ADDENDUM NO. 02

February 8, 2017

Project: Camp Murray Beach Sewer Maintenance & Historical Dist. Sewer Repairs Washington Military Department, State Project #2016-644/645

C2.1: BEACH SEWER MAINTENANCE – ADDENDUM 2 REVISIONS

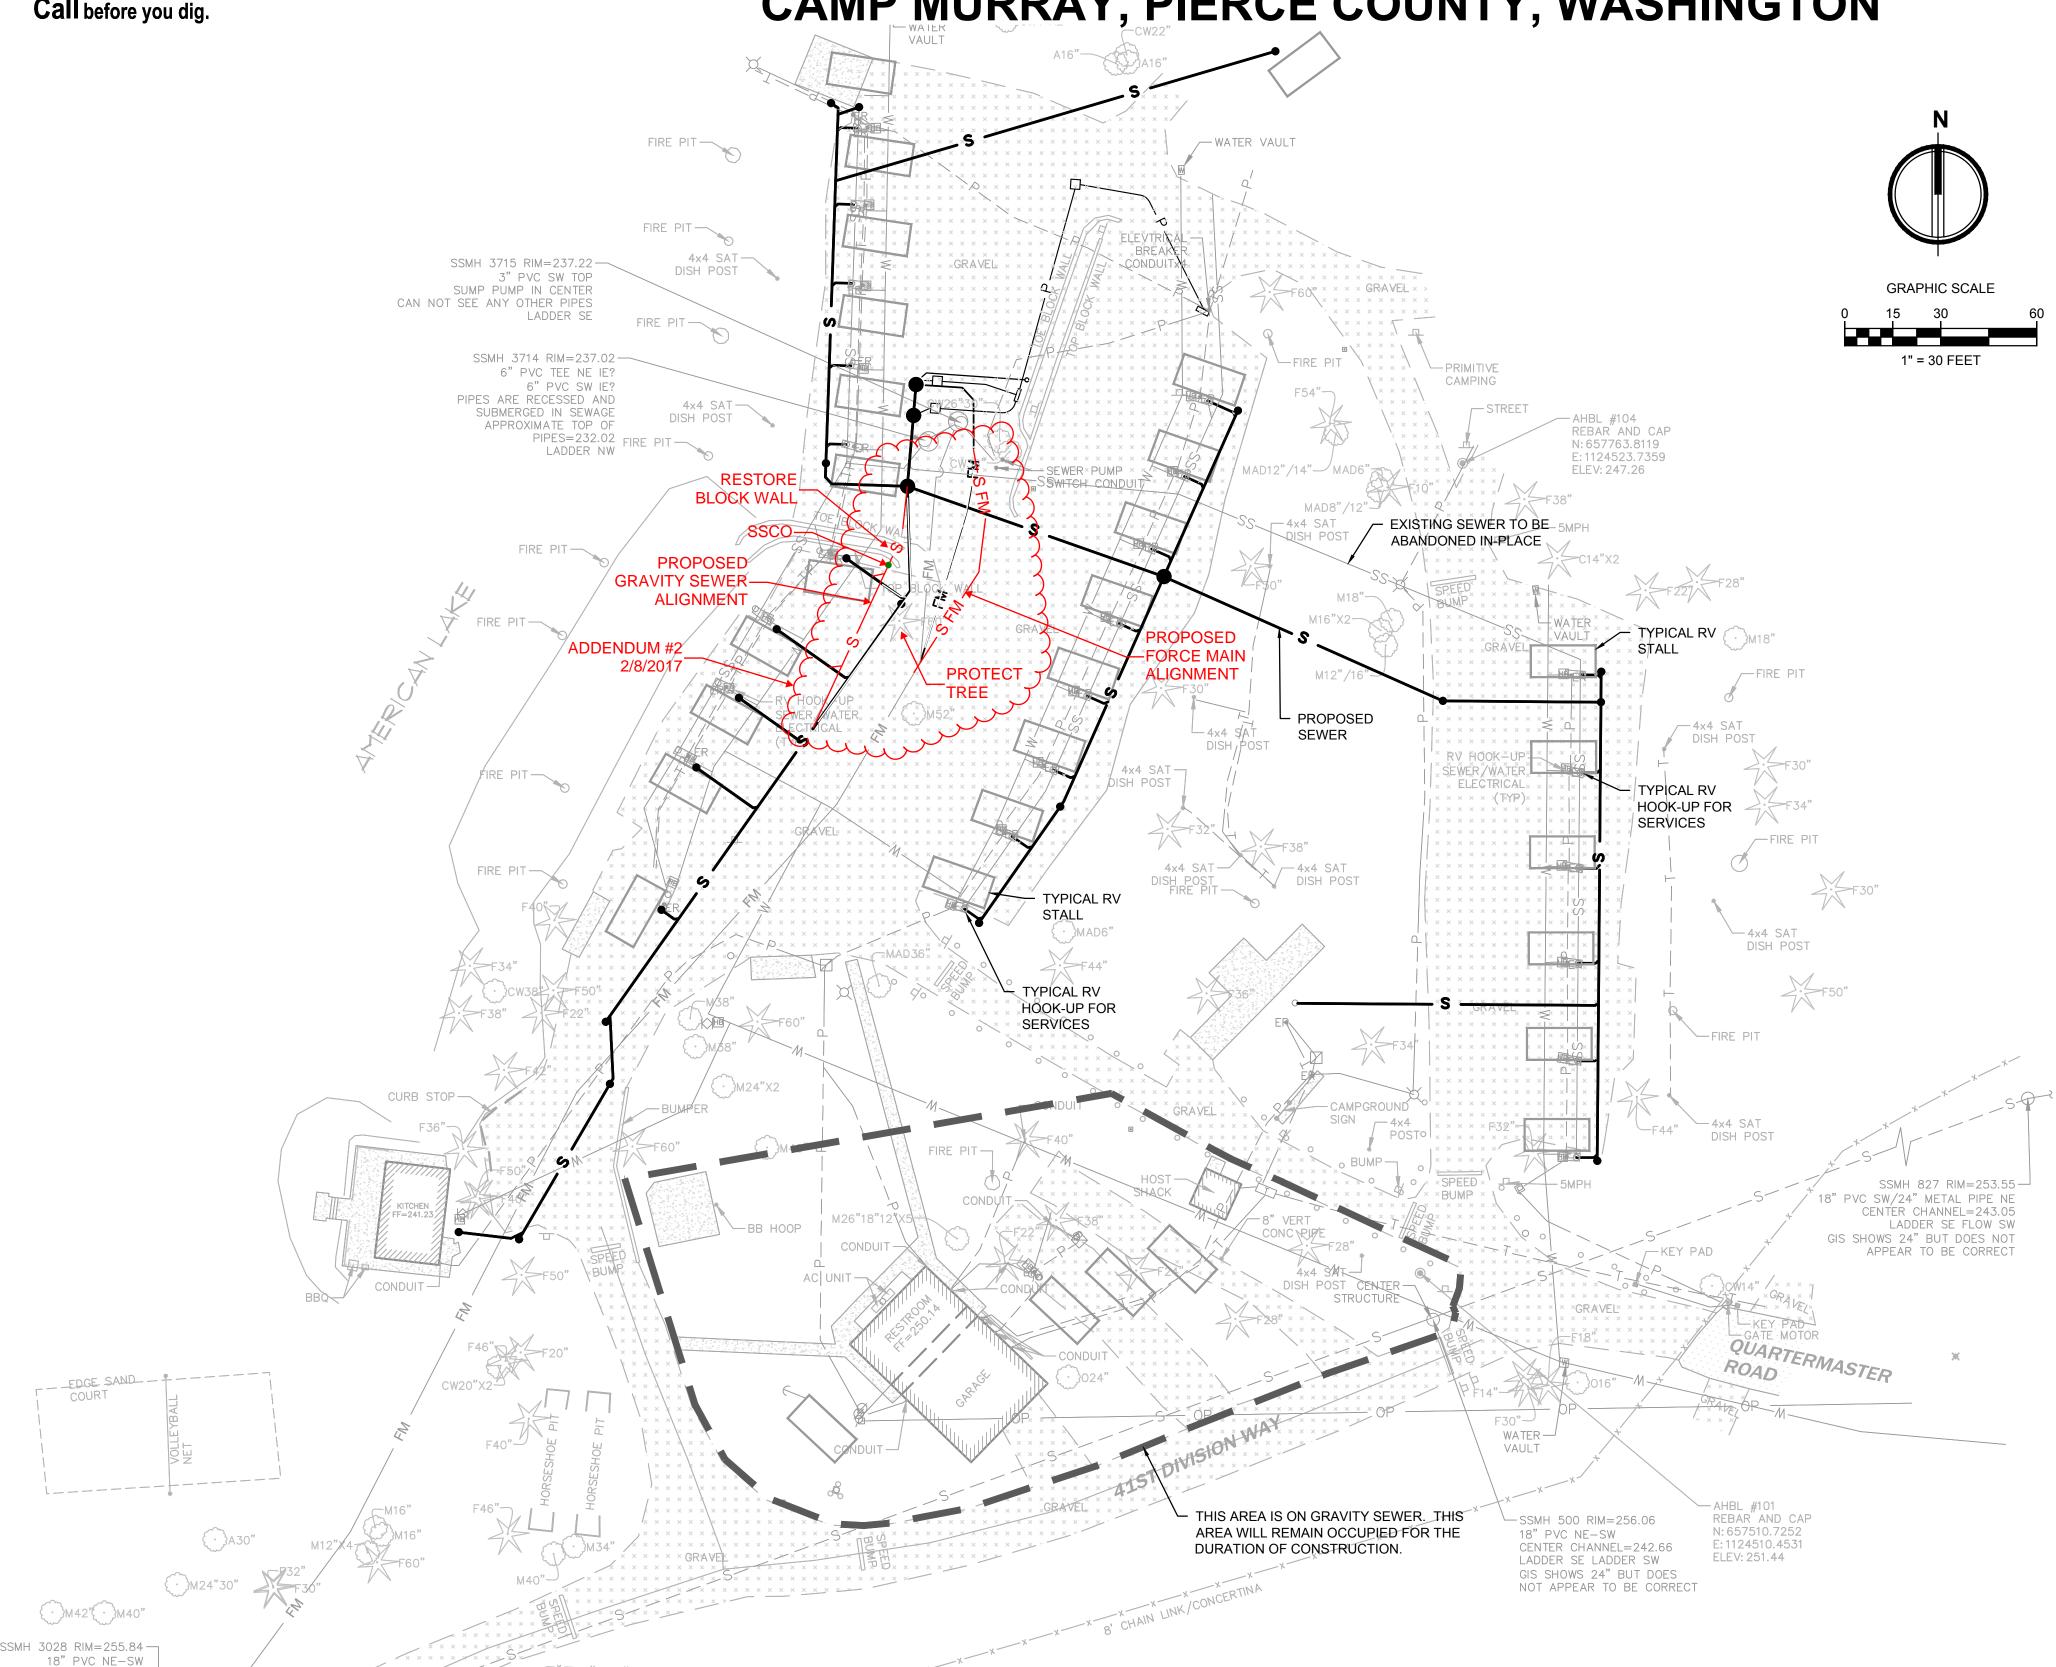
Item #CD01 C2.1 Historical District Sewer Site Plan

ADD #02 **REVISE** sewer gravity and force main alignments shown on sheet C2.1 to protect

existing tree. Refer to attachment C2.1 for Addendum revisions.
